Zoning & Subdivision Report

PRELIMINARY PLAT - WALNUT CREEK PHASE III

DATE: August 25, 2009

PURPOSE: To approve a preliminary plat to subdivide more than 11.91 acres into a 3 lot subdivision.

EXHIBIT A

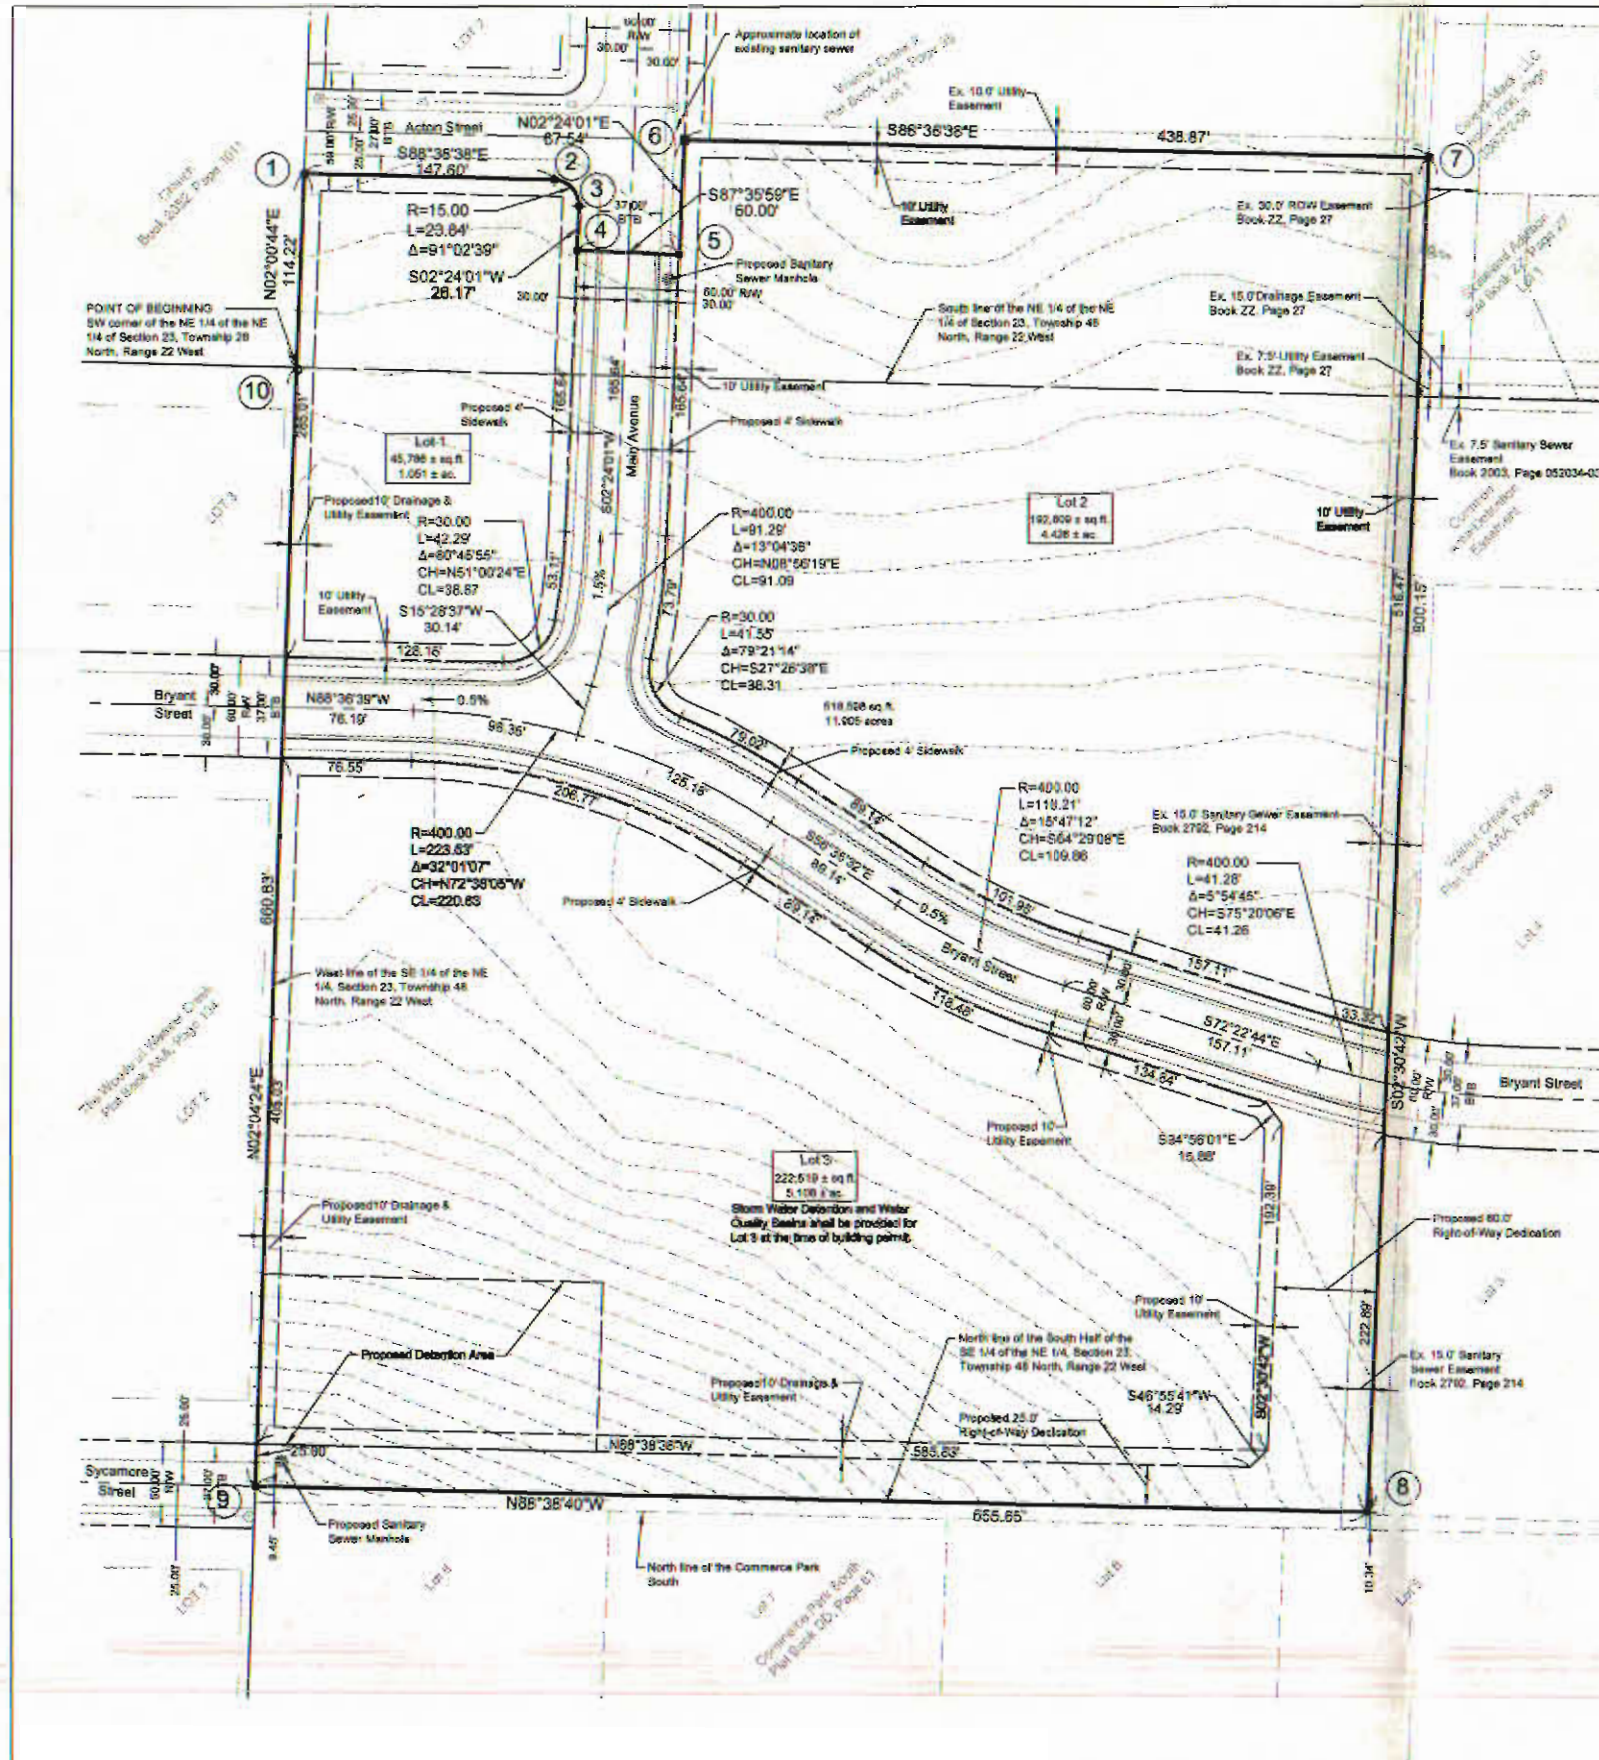
- a. Sanitary sewers shall be extended to all building sites.
 - b. Sidewalks, in accordance with the *Subdivision Regulations*, shall be constructed on both sides of Main Avenue, Bryant Street and the north/south street east of Lot 3 and on the north side of the east/west street south of Lot 3.

3. All required street rights-of-way, drainage and utility easements and limitations of access shall be dedicated on the final plat.
- a. The area for Sycamore Street and Market Avenue shall be shown as dedicated right-of-way on the final plat.

- b. A ten (10) foot by ten (10) foot right-of-way triangle shall be provided at the corners of the intersection of Sycamore Street and Market Avenue and Market Avenue and Bryant Street.

1. Will any cross-access easement be necessary between Lot 2, Phase III and Lot 1, Phase II based on desired final development plan?
2. The intersection layout to Bryant Street and Main Avenue would be acceptable only with multi-way stop control. The applicant has provided traffic volume projections for ultimate development and Level of Service analysis for recommendation of appropriate traffic control at the intersection. Based on the report submitted, Traffic Engineering supports a three-way stop at the intersection.

3. Show the area for Sycamore Street and Market Avenue as dedicated right-of-way on the final plat. Provide 10-foot by 10-foot triangles at the corners.

1. Detention / water quality requirements for Lots 1 and 2 were provided with Phase 1 of this development. Lot 3 detention / water quality requirements will be required at time of development as noted on the preliminary plat. The stormwater facility will not be required to be within common area or a drainage easement as long as it only accepts and serves one lot.

2. Drainage patterns for any runoff currently flowing across the site must not be blocked or altered by any future construction.
3. Any increase in impervious area from 1983 aerial photo information will require the development to meet current detention and water quality requirements. Impervious surfaces in place prior to 1983 and in currently in good condition can be credited as existing impervious surface.

4. Concentrated points of discharge from these improvements will be required to drain into a natural channel, public right-of-way, or a drainage easement.
